**ADDENDUM NO. 1**

DATE: 7/15/2022

PROJECT: Lake Ouachita Water Supply Project
Phase 3– Water Treatment Plant
Hot Springs, ArkansasBID DATE: July 26, 2:00 PM

CITY OF HOT SPRINGS, ARKANSAS
LAKE OUACHITA WATER SUPPLY PROJECT
WATER TREATMENT PLANT
BID SET
PHASE 3 - TREATMENT PLANT
FTW BOX PLAN AND SECTIONS

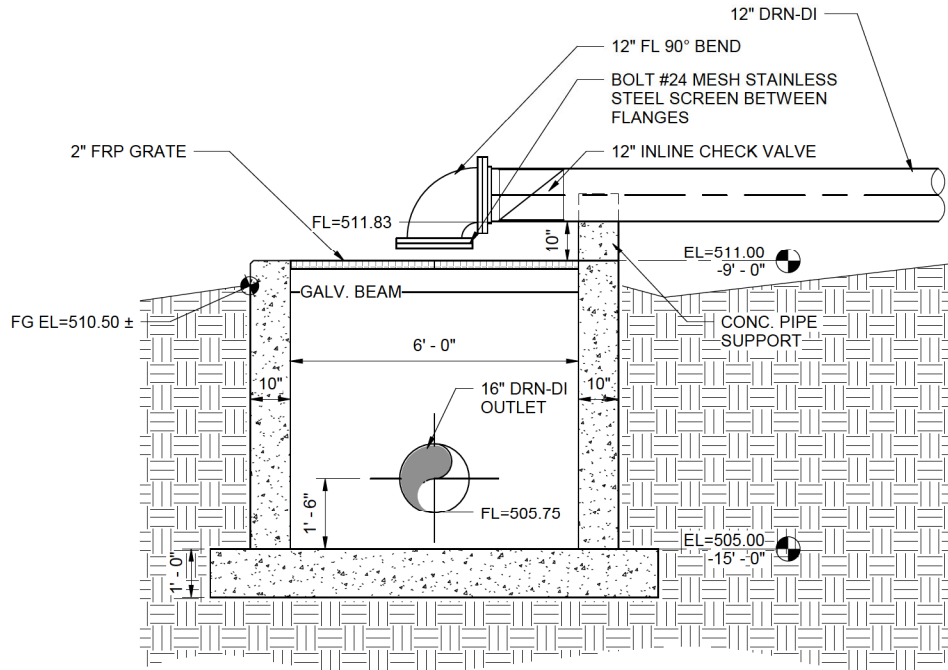
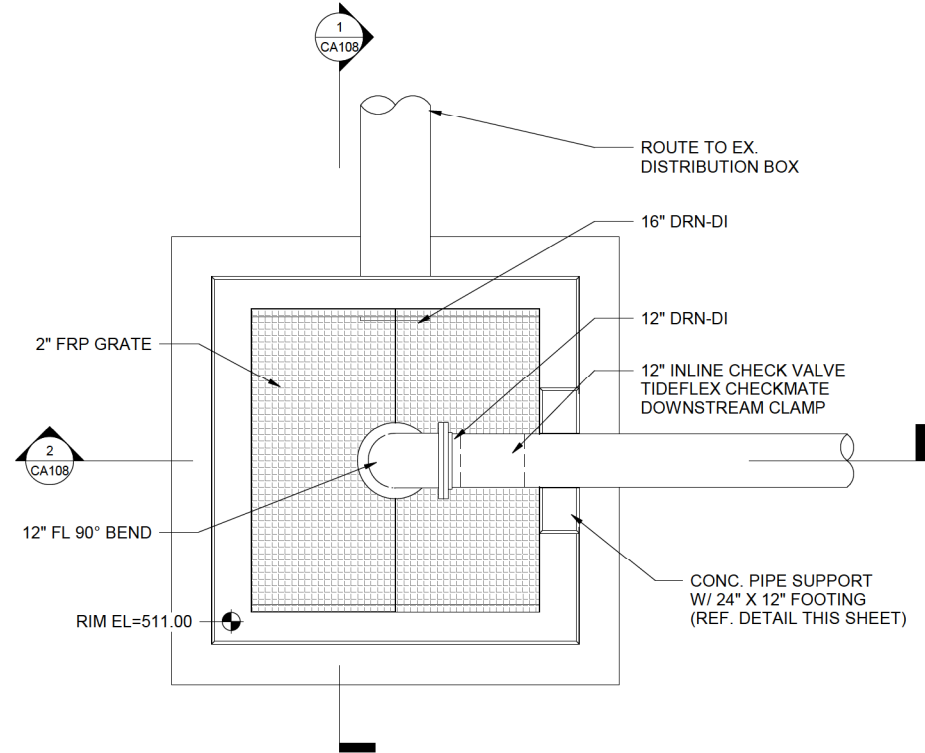
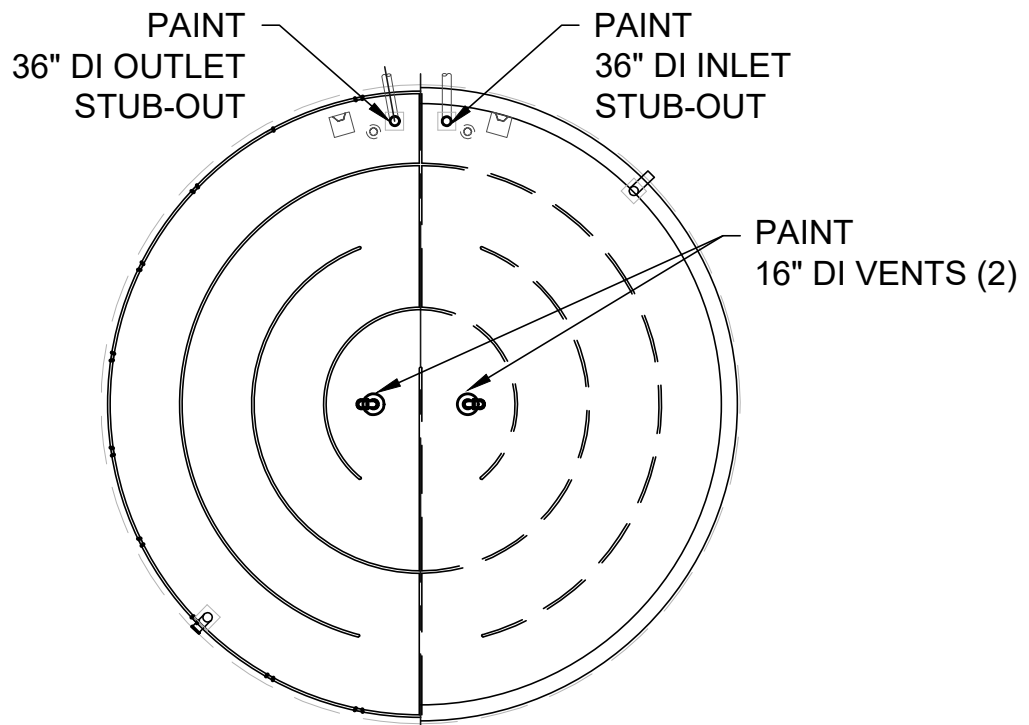
Item No. 28. Construction Drawings – Sheet CA108 – FTW Box Plan and Sections

See revised sheet herein:

EXISTING 3MG CLEARWELL
PAINTING DETAIL

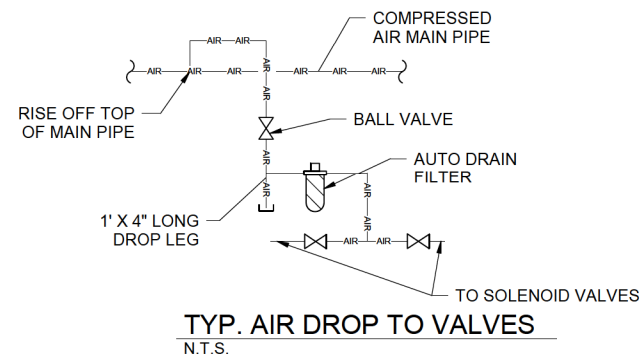
Add additional Note to plans as follows:

2. Contractor shall paint Existing Clearwell 16" ductile iron vents as well as the 36" ductile iron inlet and outlet pipes on the interior of the Existing Clearwell.

CITY OF HOT SPRINGS, ARKANSAS
LAKE OUACHITA WATER SUPPLY PROJECT
WATER TREATMENT PLANT
BID SET
PHASE 3 - TREATMENT PLANT
AIR PIPING DETAILS

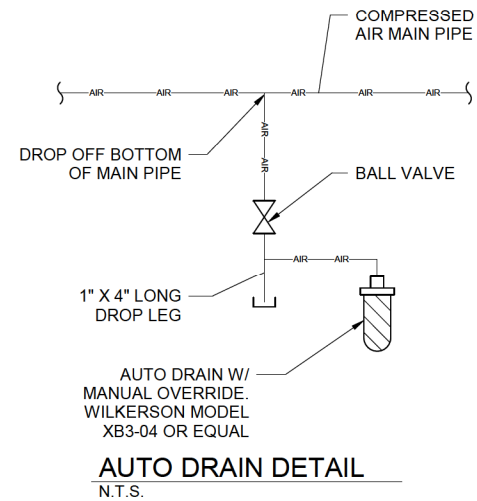
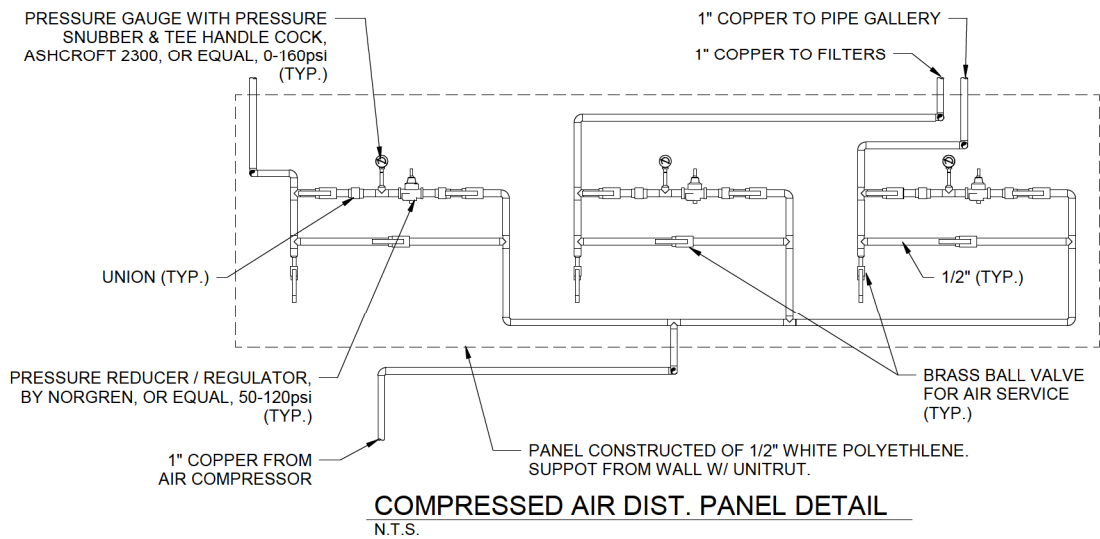
Item No. 36. Construction Drawings – Sheet CC226 – Air Piping Details

Added Sheet CC226 to Construction drawings: see sheet herein.
